D240002: New Zealand Transport Agency Notice of Requirement SH 1 Rolleston Access Improvements

Request for further information

Title:	SPILL LIGHTING LAYOUT SHEET 1 OF 5
--------	------------------------------------

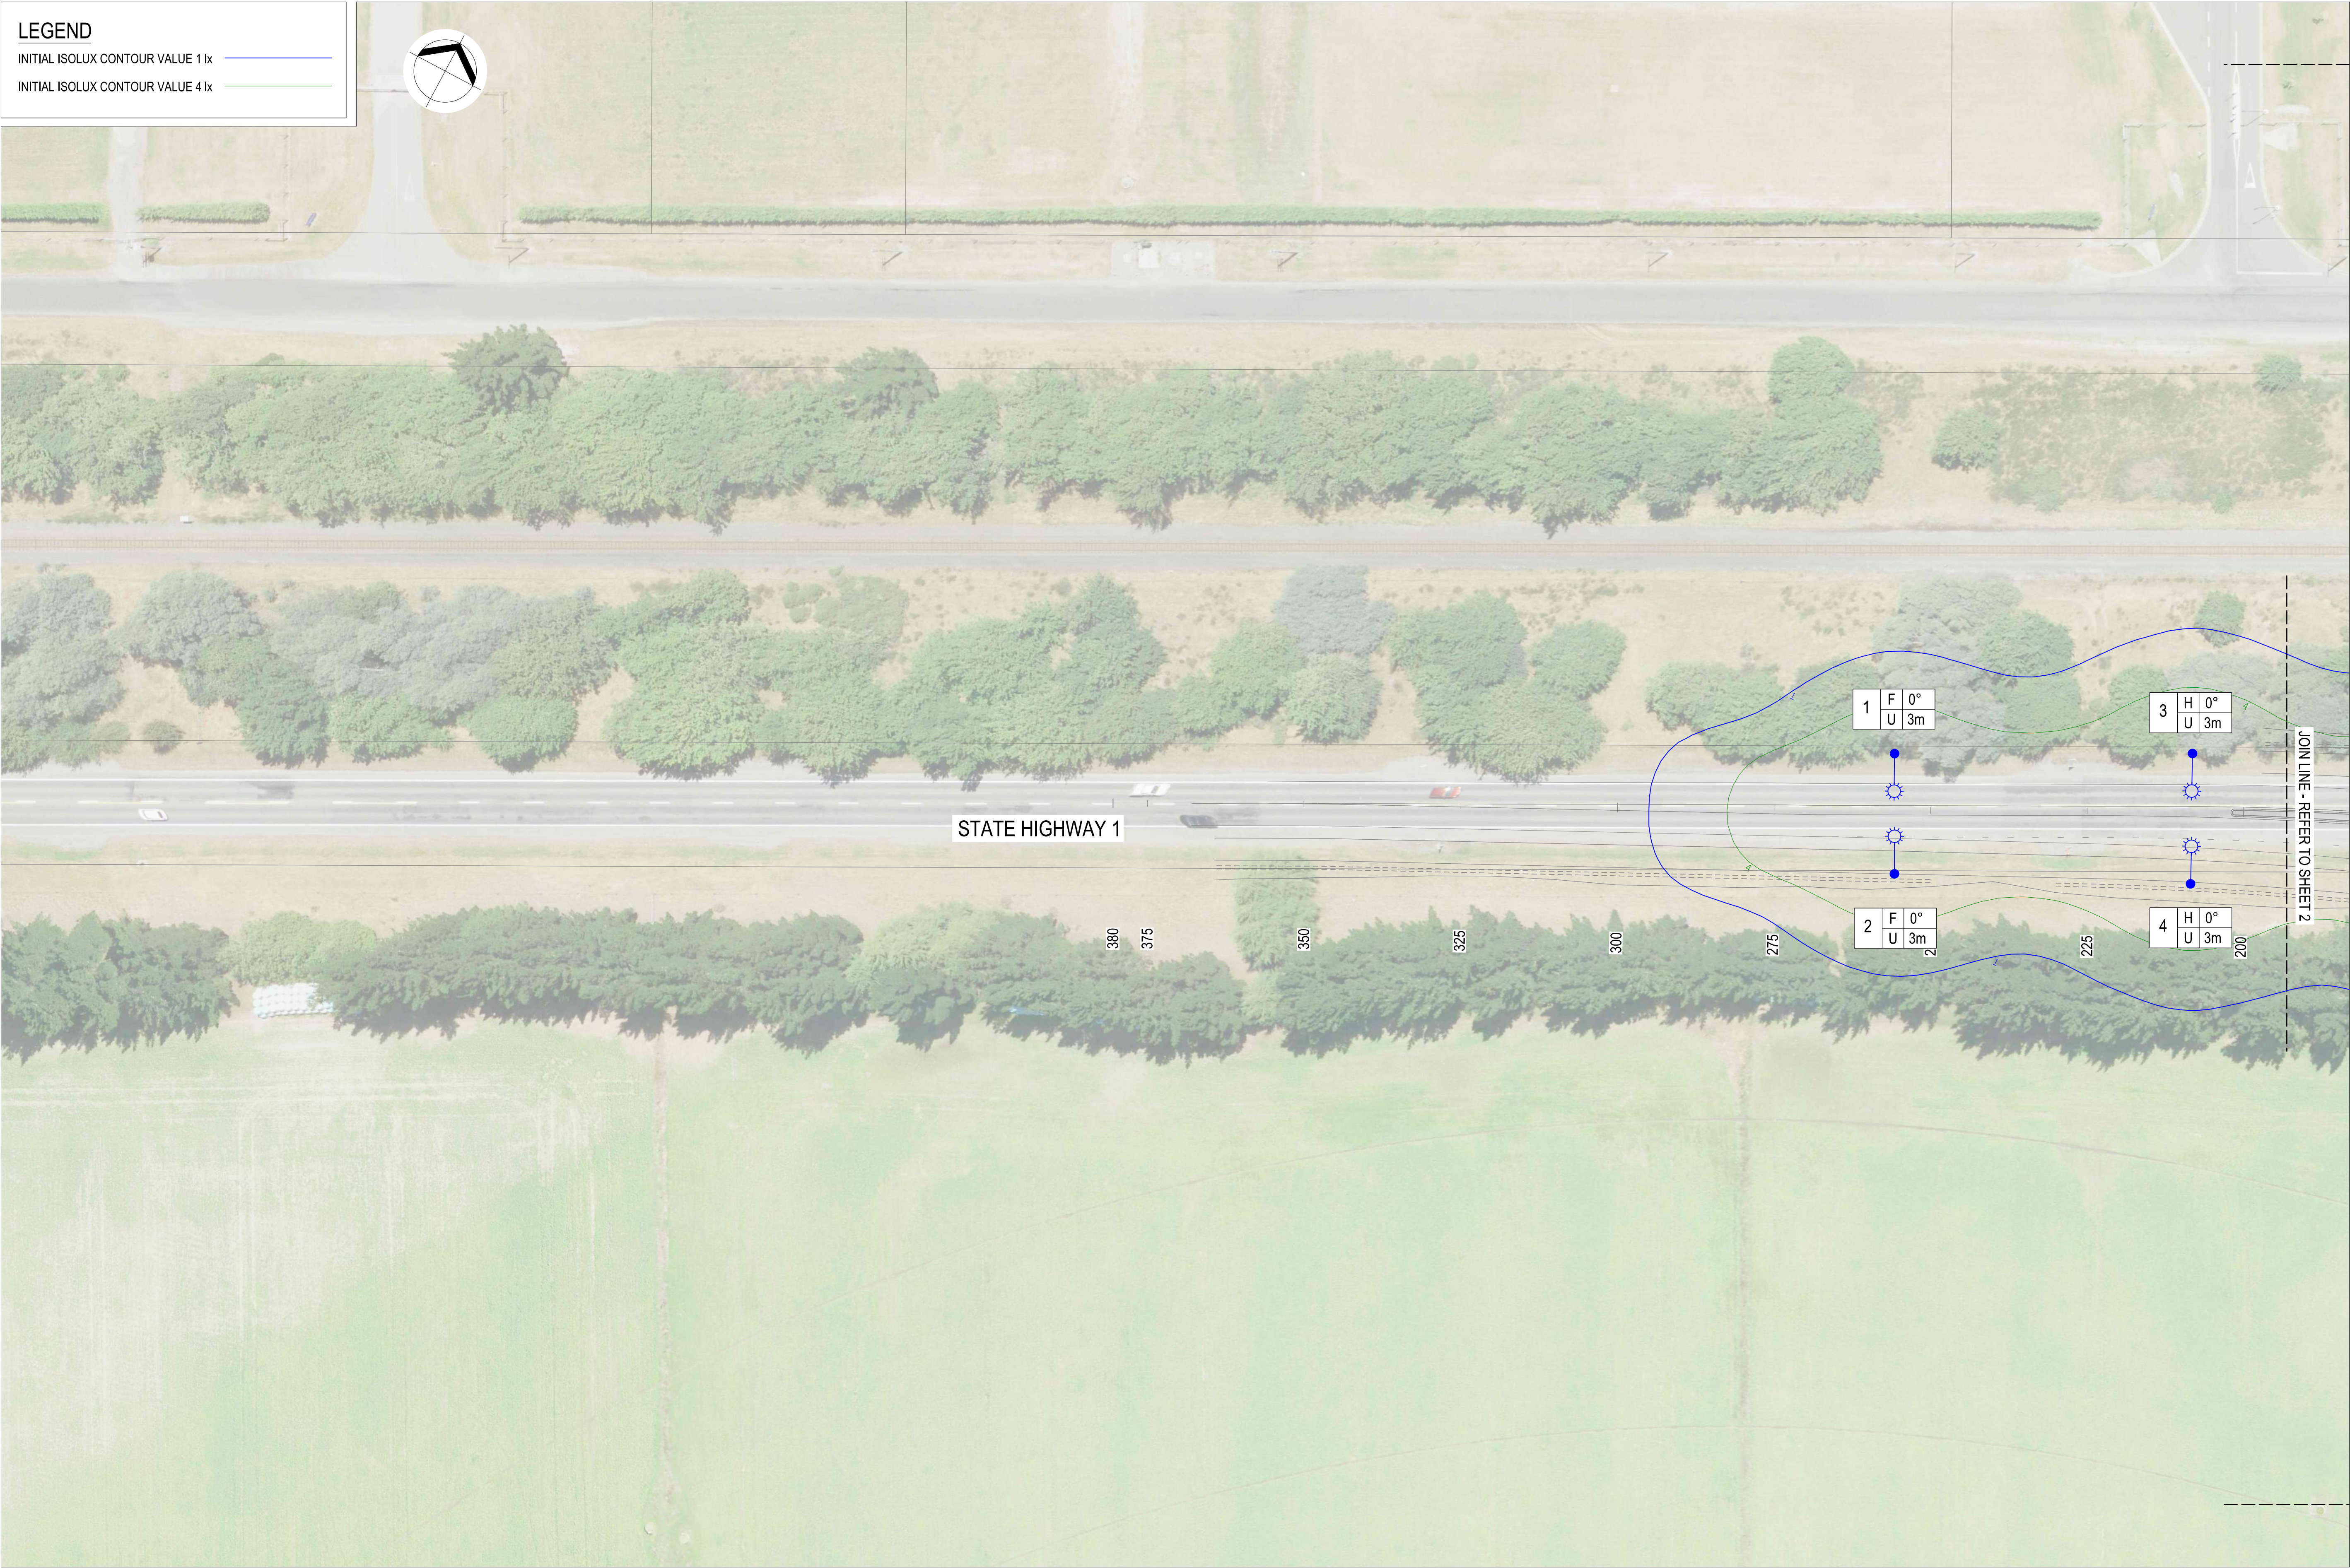
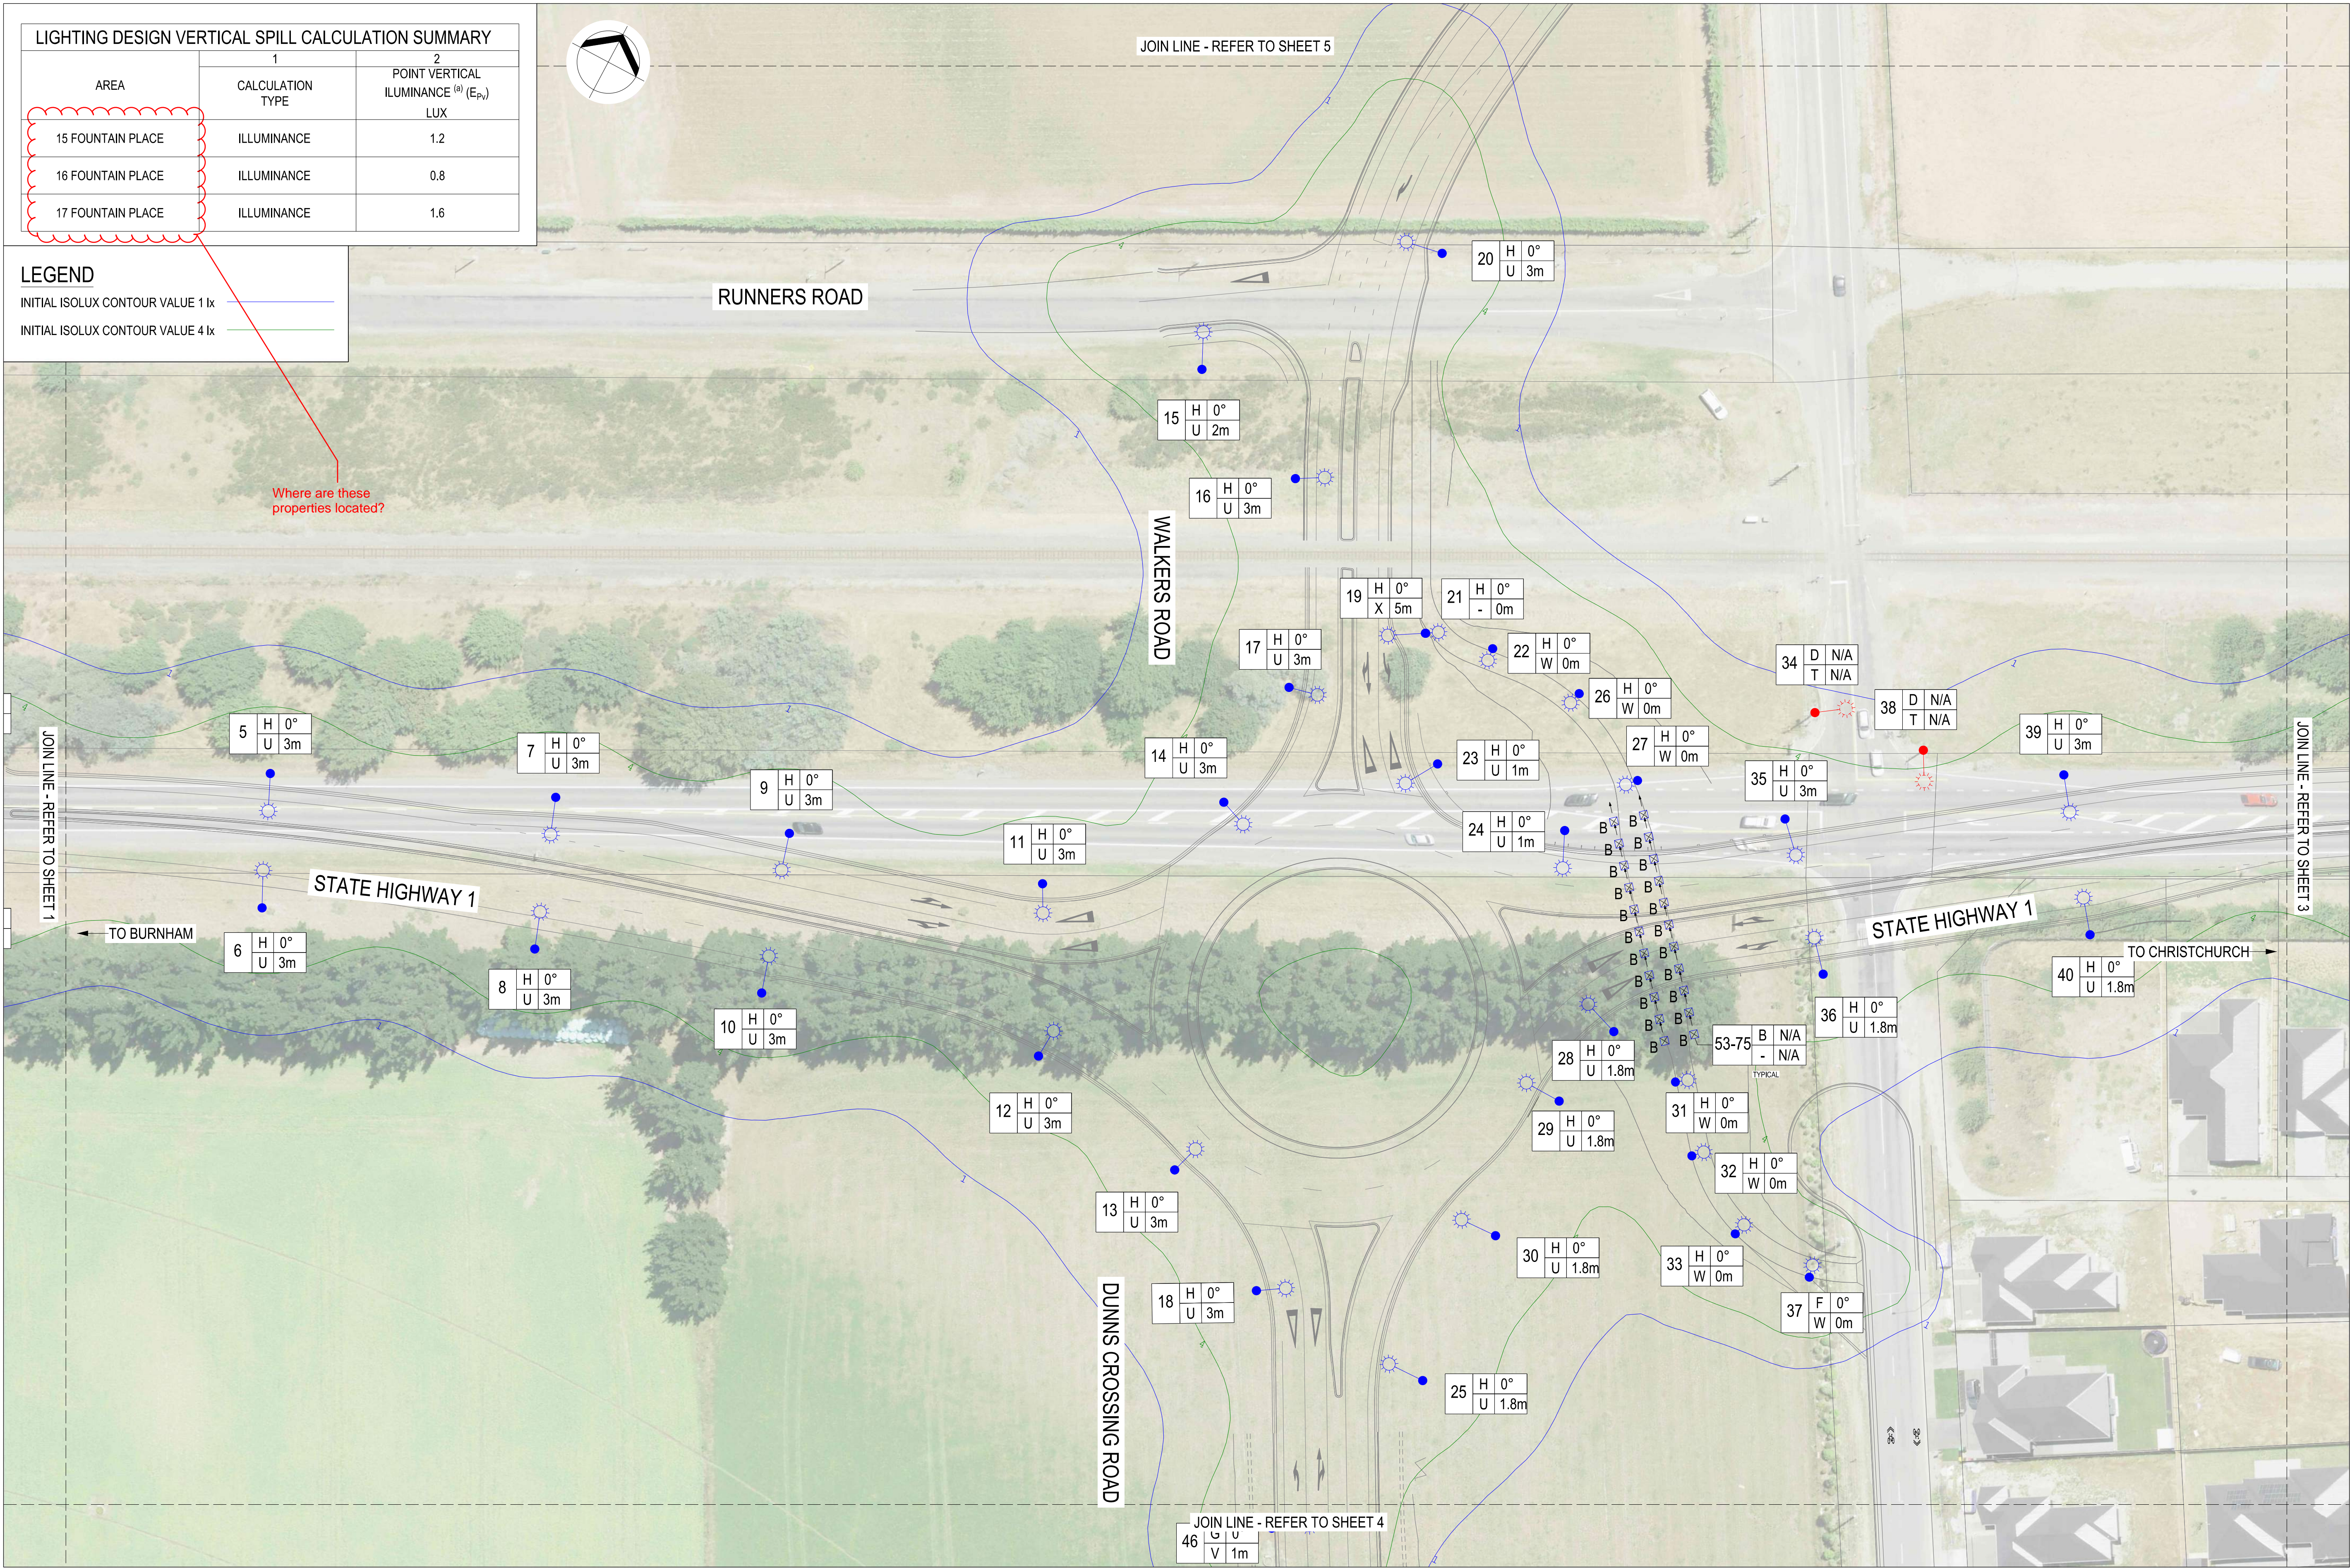
24. Drawings 3338703-10-CU-3532 to 3534 - These drawings show spill light calculation results for certain address (e.g. 15 Fountain Place), however none of these drawings show the property numbers so there is no way to correlate the calculation results with the properties without having to look up Google maps. *Please get the lighting designer to add the street addresses to the evaluated properties.*
